Make a Planning Appeal

Planning authority Kildare County Council
Planning authority register reference number 25/61119
Address of proposed development Lands at Railpark
Maynooth
County Kildare

Grounds of Appeal

The residents of Parklands listed in Appendix A wish to appeal the decision of Kildare County Council to grant planning permission for the Railpark development (Planning Ref. 25/61119) in Maynooth.

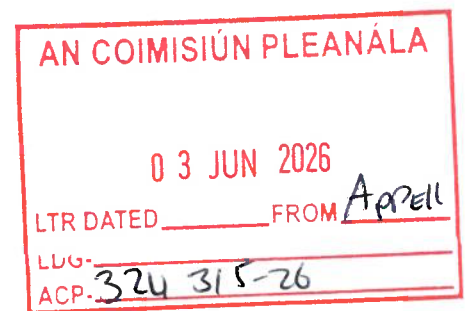
Footnote 49 to Table 7.1 confirms that PERM 61 was deleted from the adopted LAP “Additionally, measures PERM 4, PERM 7, PERM 10, PERM 11, PERM 17, PERM 18, PERM 24, PERM 44, PERM 46, PERM 52, **PERM 61**, PERM 75 were removed by a **material alteration** approved by the Elected Members during the making of the Plan.”
Page 126 Maynooth Local Area Plan.

Figure 2.1: Site Layout as Originally Proposed

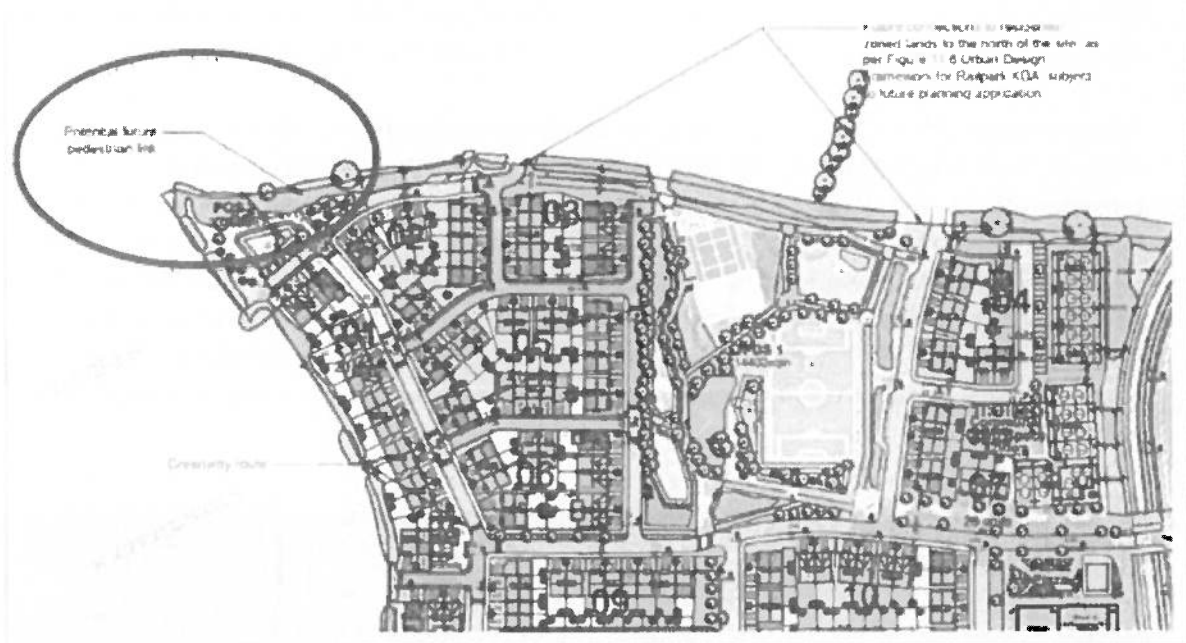
I welcome the removal of the proposed pedestrian and cycle access into *Parklands Lawns* from the Cozone Development (Ref. 25/61119), as reflected in the updated plans and maps. As outlined in The Parklands Residents Association Submission, there were a number of significant concerns underlying our objection to this access.

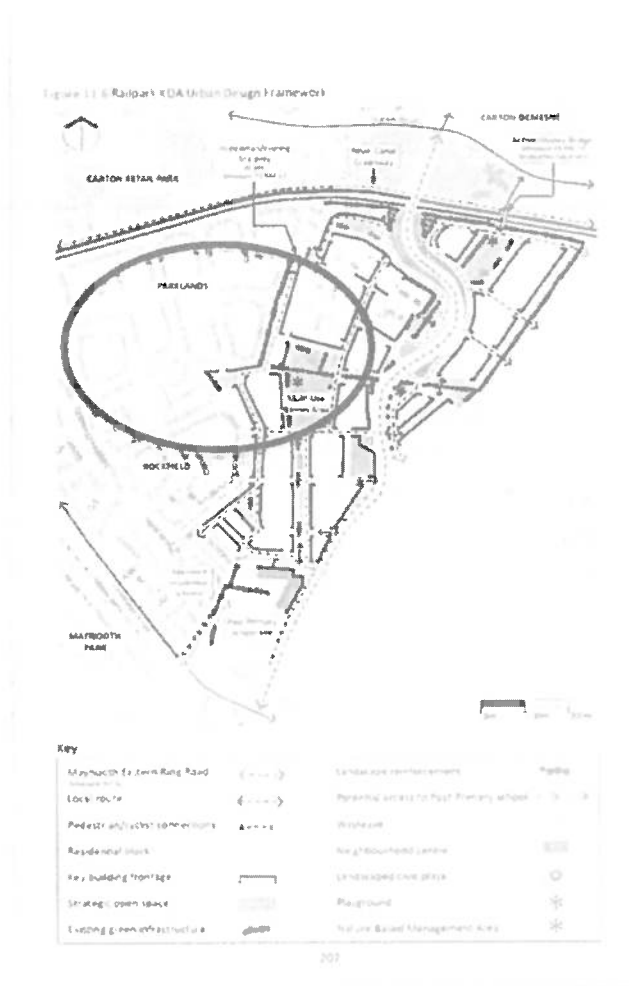
Despite the removal of PERM 61, the planning application continues to refer to a potential future pedestrian connection through Parklands Lawns. The Parklands Residences listed in Appendix A submissions notes that *Figure 11.6 of the adopted Local Area Plan* shows the permeability routes intended to serve the Railpark Key Development Area.

No pedestrian, cycle or vehicular connection between Railpark and Parklands Lawns is shown on this map. In simple terms, the adopted Local Area Plan does not provide for a connection at this location.

Figure 11.6 of the 2025-2031 LAP identifies the totality of the permeability routes in the Railpark development. You will see that a route (pedestrian or otherwise) from any proposed development in Railpark into the Parklands estate does not feature on this map. There is also no indication from the 2025-2031 LAP that any such route may be considered by the Council in the future.

The Board is respectfully requested to amend the permission by removing all references to any existing or future pedestrian or cycle connection through Parklands Lawns and to ensure that the development fully complies with the adopted Local Area Plan.

Unacceptable Boundary Treatment already proposed in Rockfield

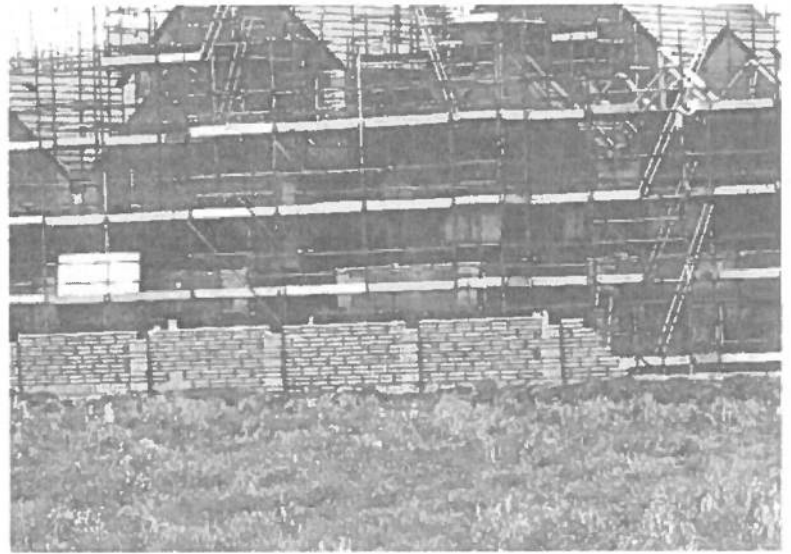
The proposed boundary treatment for Rockfield consists of a 1.8m high timber panel fence with concrete posts, terminating at the approach to the green space adjacent to Rockfield Grove, Parklands Lawns, and Parklands Place. We wish to highlight that, in our view, a timber panel boundary in a neighbouring residential estate is not an adequate or appropriate solution in terms of durability, appearance, or long-term maintenance. We fully support the residents of the adjoining Rockfield estate in their concerns and share their position that a more suitable and robust boundary treatment should be considered for both locations.
